DOCUMENT 009113 - ADDENDA

- A. Addendum No. Two.

- A. Project Name: Skatium Locker Room Renovation.
- B. Owner: Township of Haverford.
- C. Owner's Representative: C.B. Development Services, Inc.
- D. Architect: BKP Architects.
- E. Date of Addendum: October 4, 2024

Skatium Locker Room Renovation
Responses to Bidder Questions and Written Identification of Modifications to Project Documents

1"=1'-0"

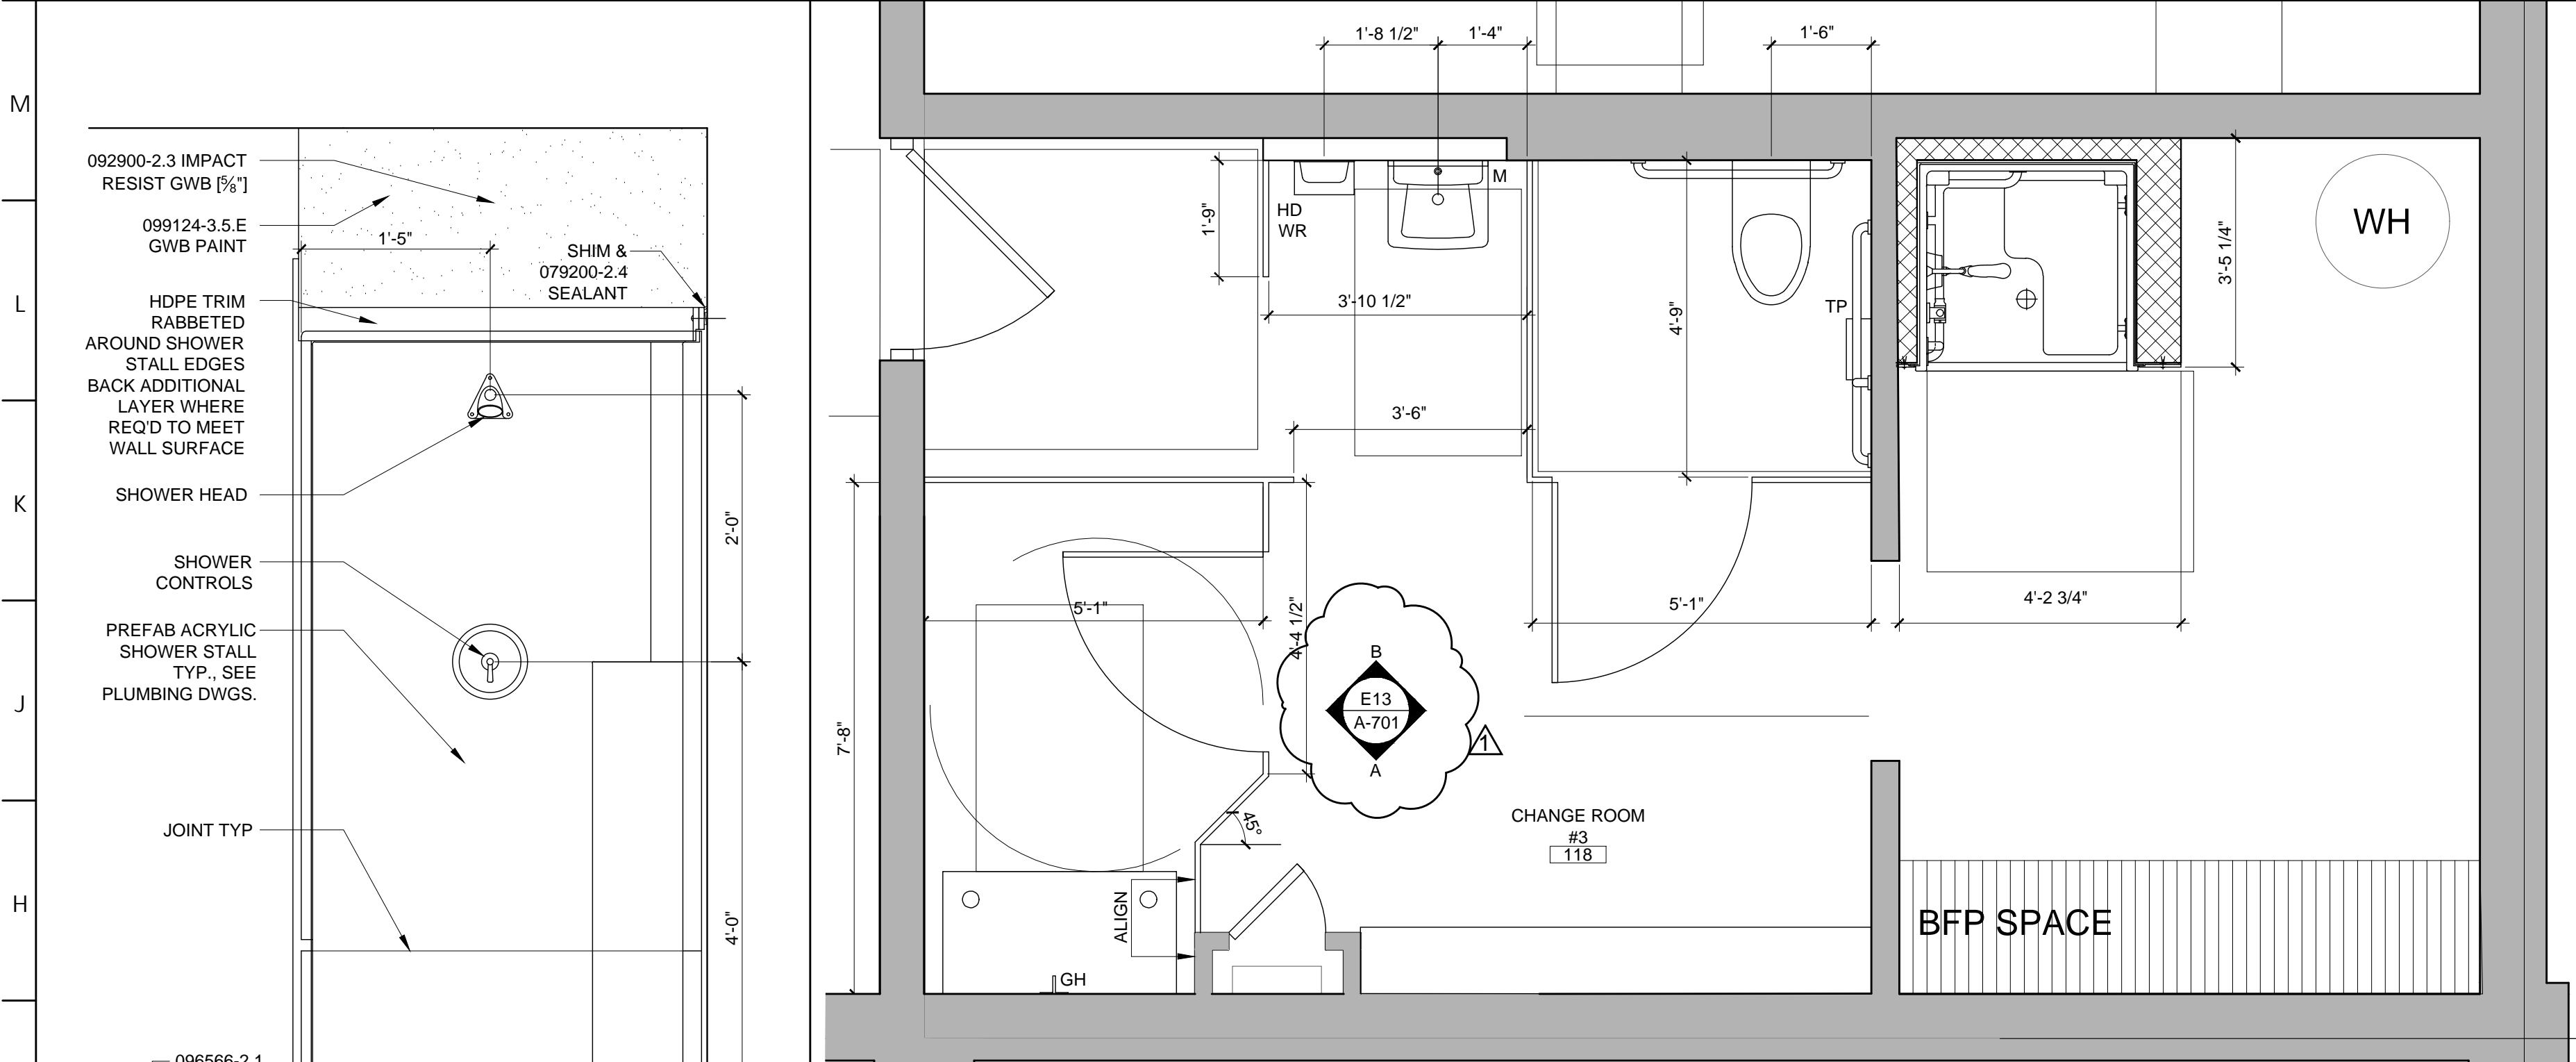
8. Several sheets reference Sheet A-100 which does not exist. Please advise.

- K. Drawing A-602 has been modified, removing references to Sheet A-100, replaced with reference to Sheet A-701.

Reference to Sheet A-100 should have been A-701. Drawing sheets A-601 and A-602, which are affected by this change have been revised and issued with Addendum #2.

DRAWING NO:
G-003

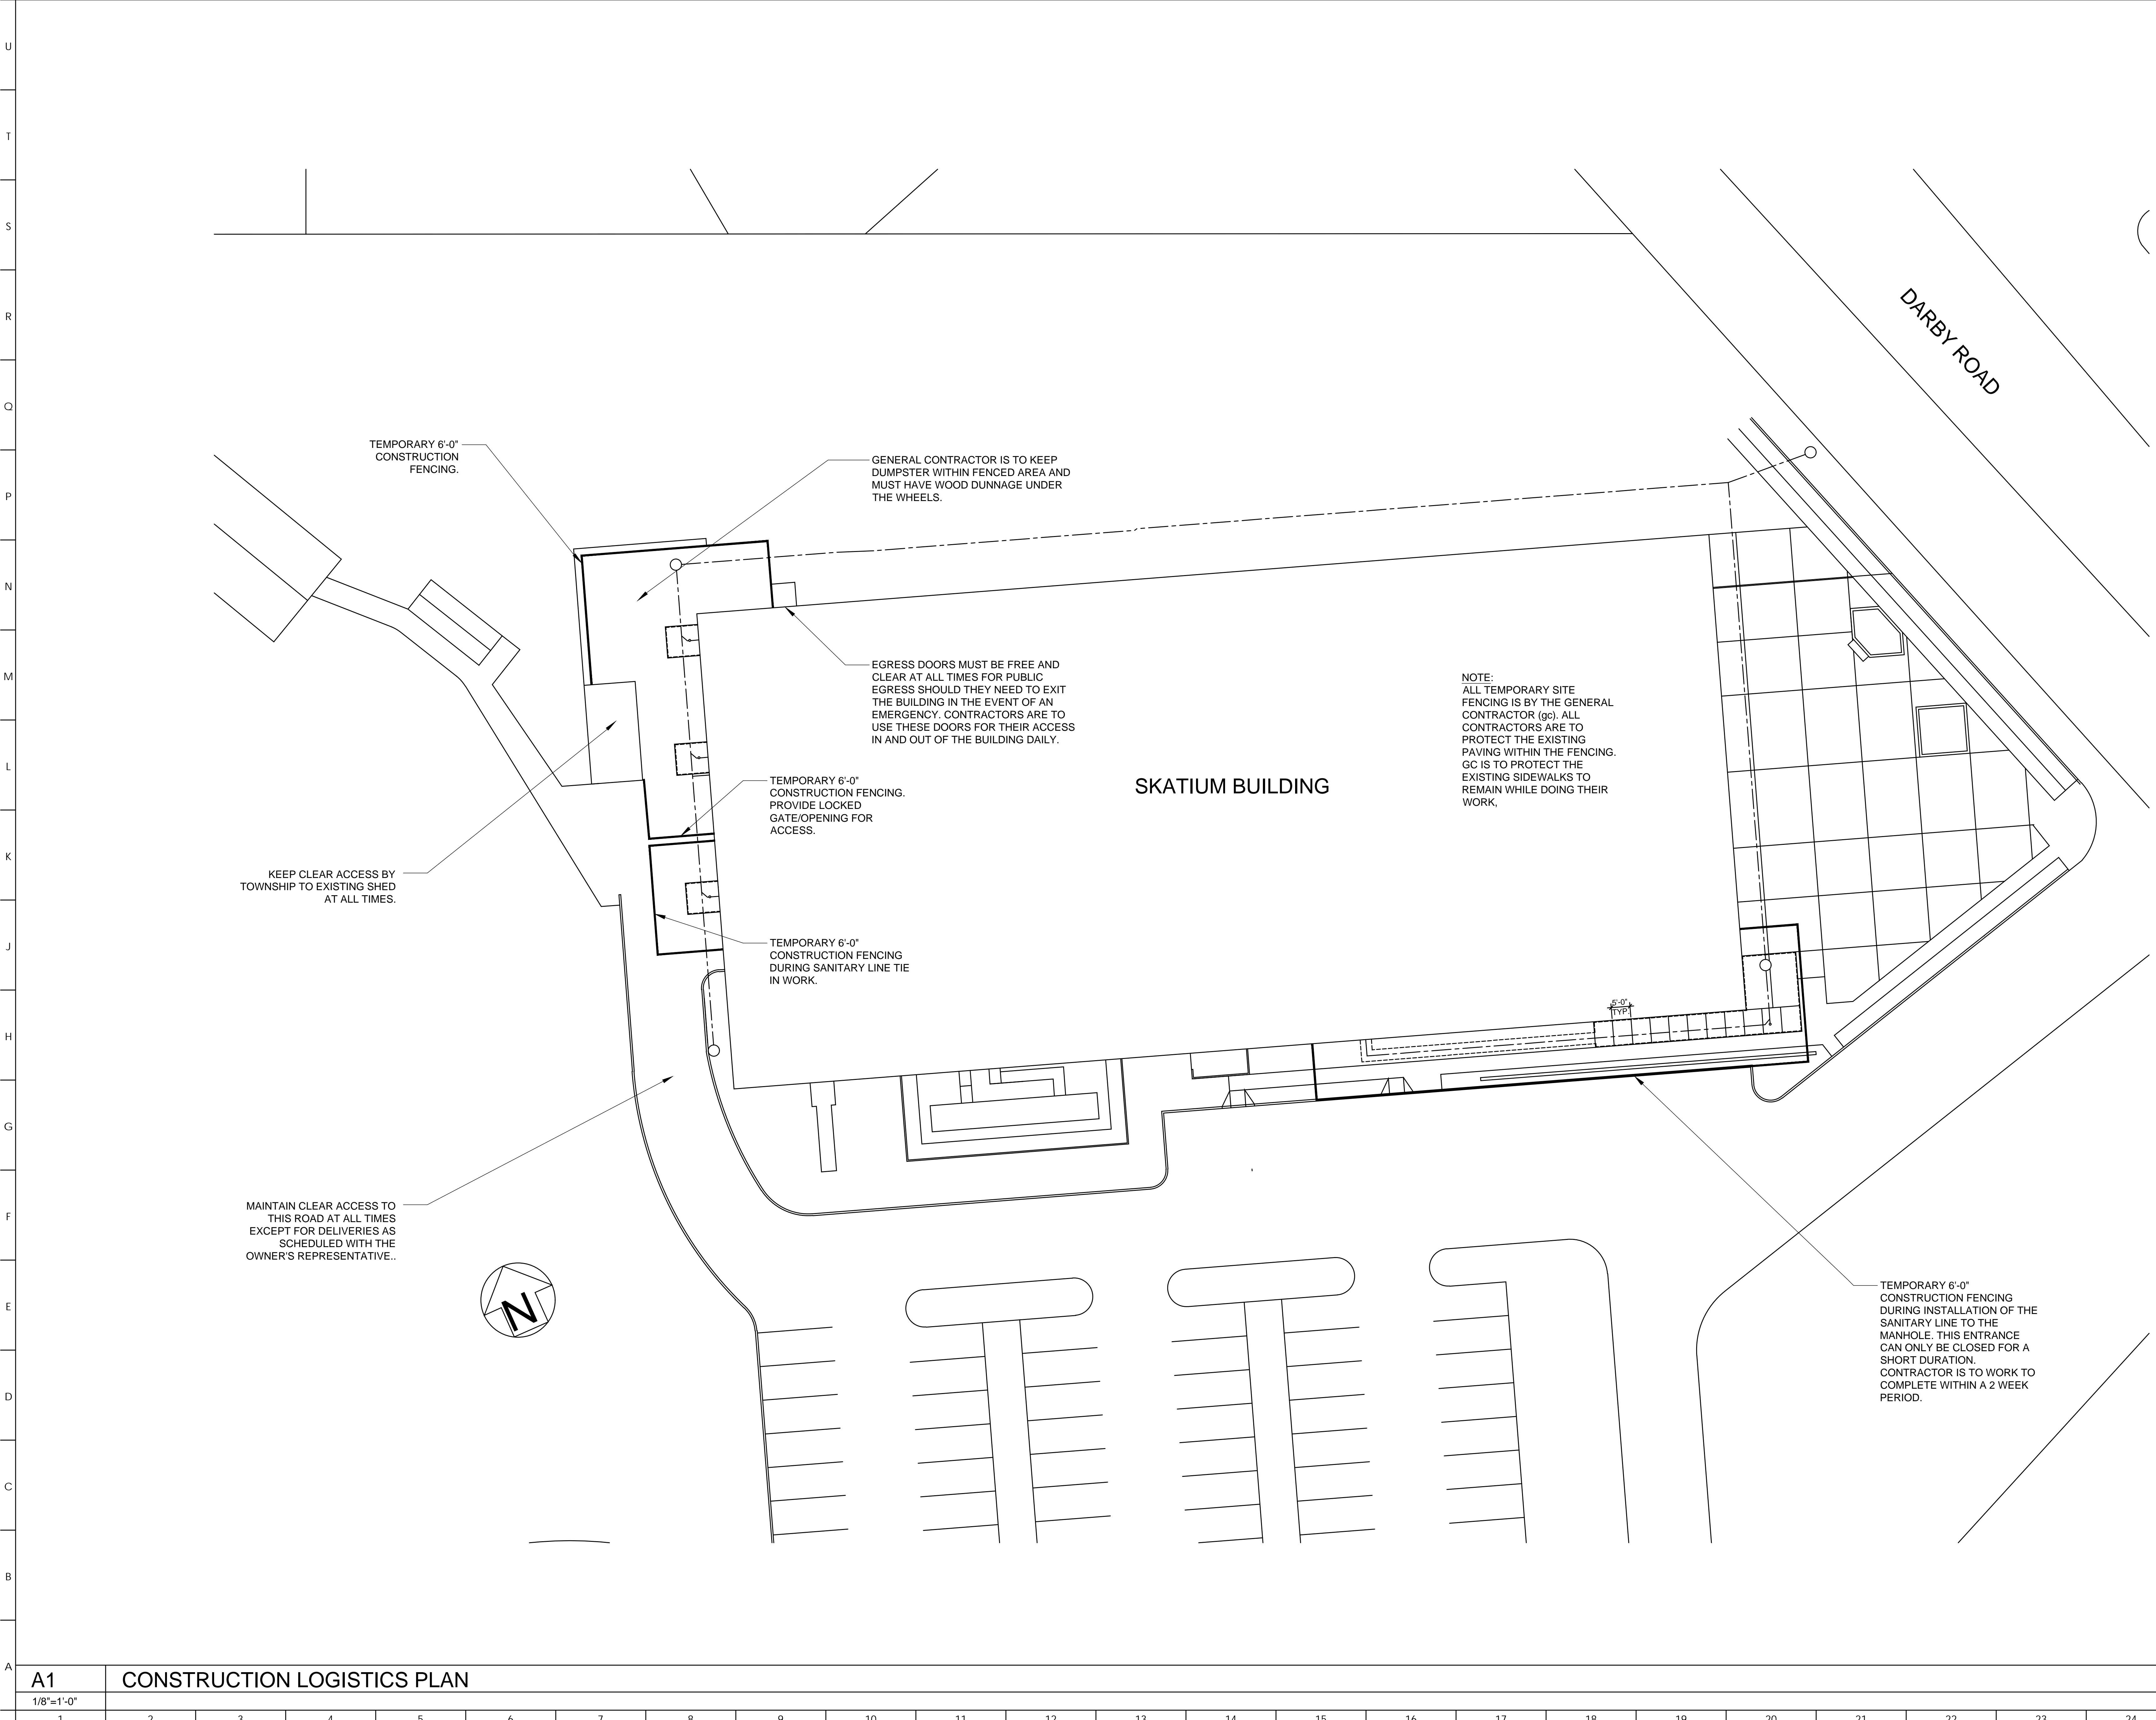
- G. Drawing G-003 has been added.
- H. Drawing A-001 has been modified to include Contractor option to direction bore instead of excavation for new sanitary line.
